Document Number: D10122-A-G0190

Notice of Change to Individual Bag for Connectivity Module

Connrctivity Module Family

Change① Caution Label

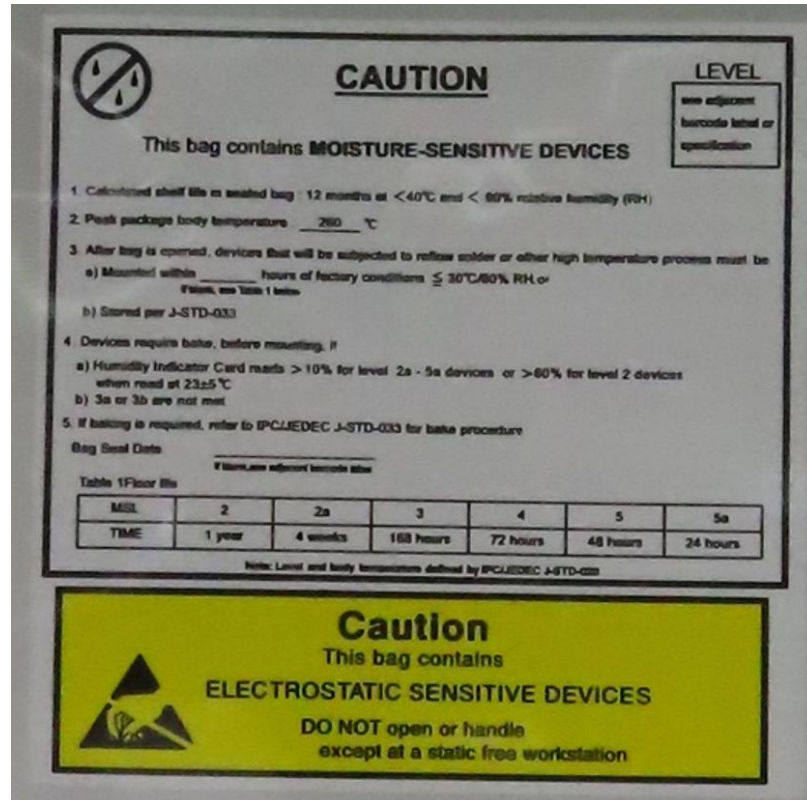
- Comparison of Caution label sticker application and Caution label printing conditions

Before :

Sticking a label

After :

Label printed

Change① Caution Label

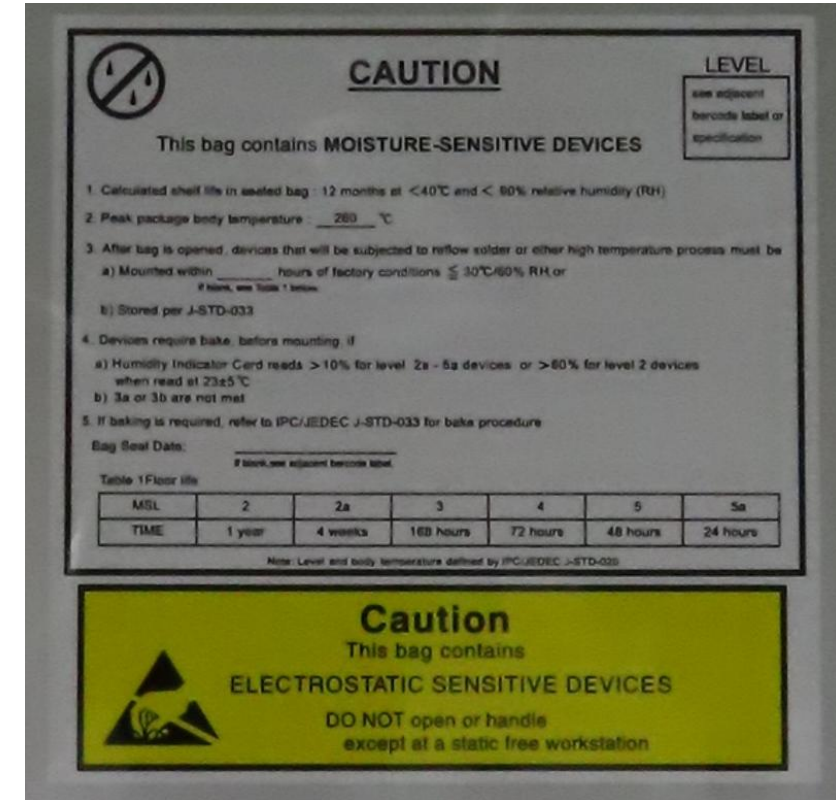
- Comparison of Caution label stickers and Caution label printed labels

Before :
Label sticker

After :
Label print

Change② Corners of aluminum bag

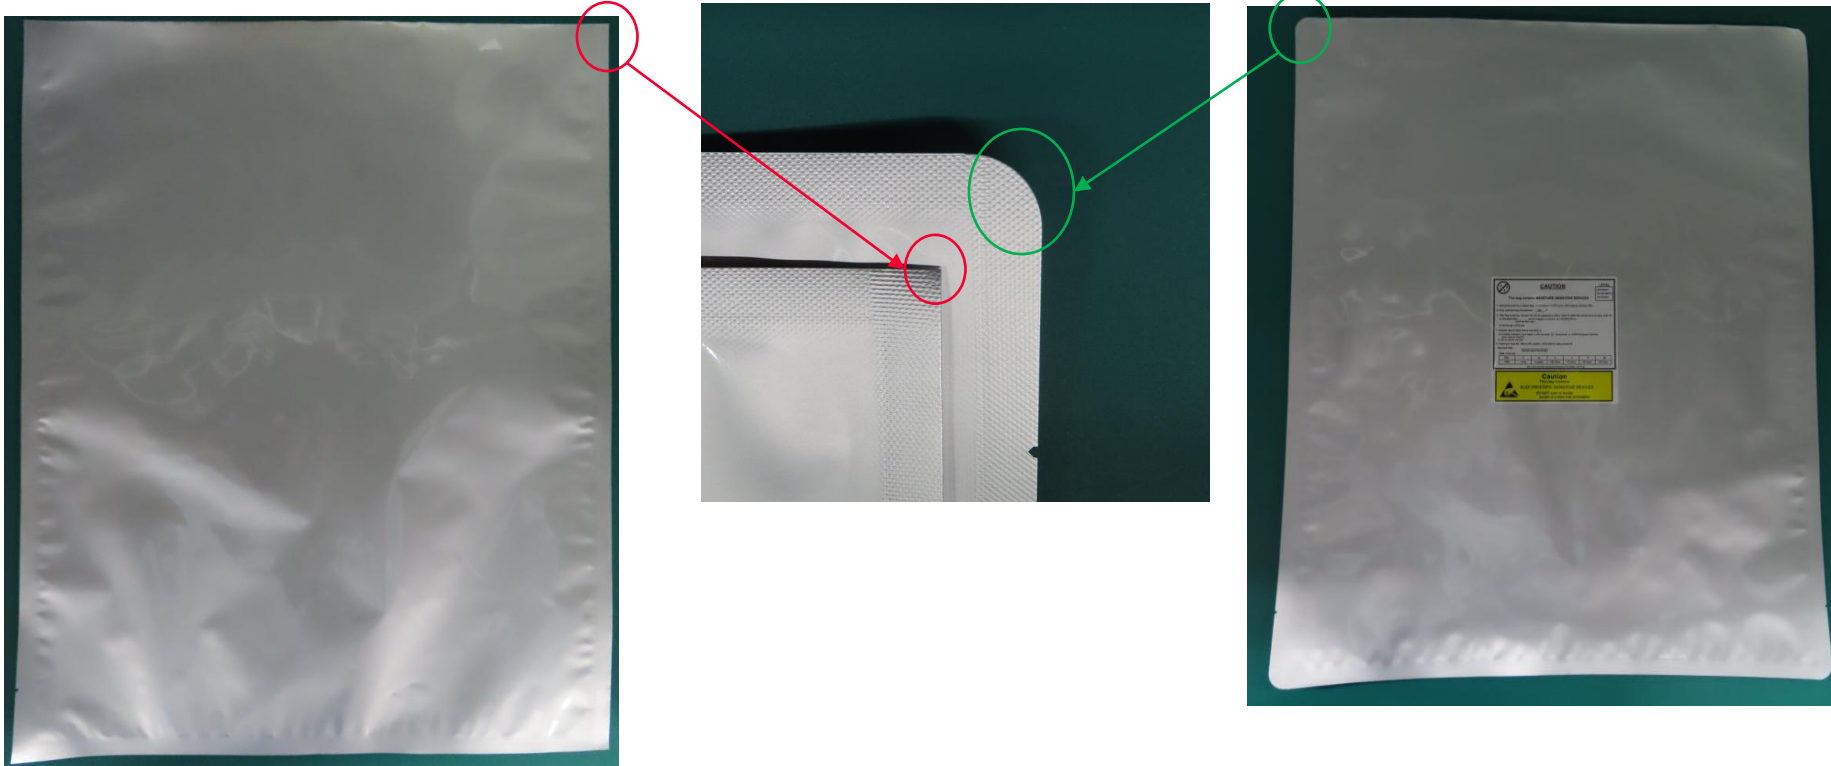
Before :
Right angle

After :
Curved
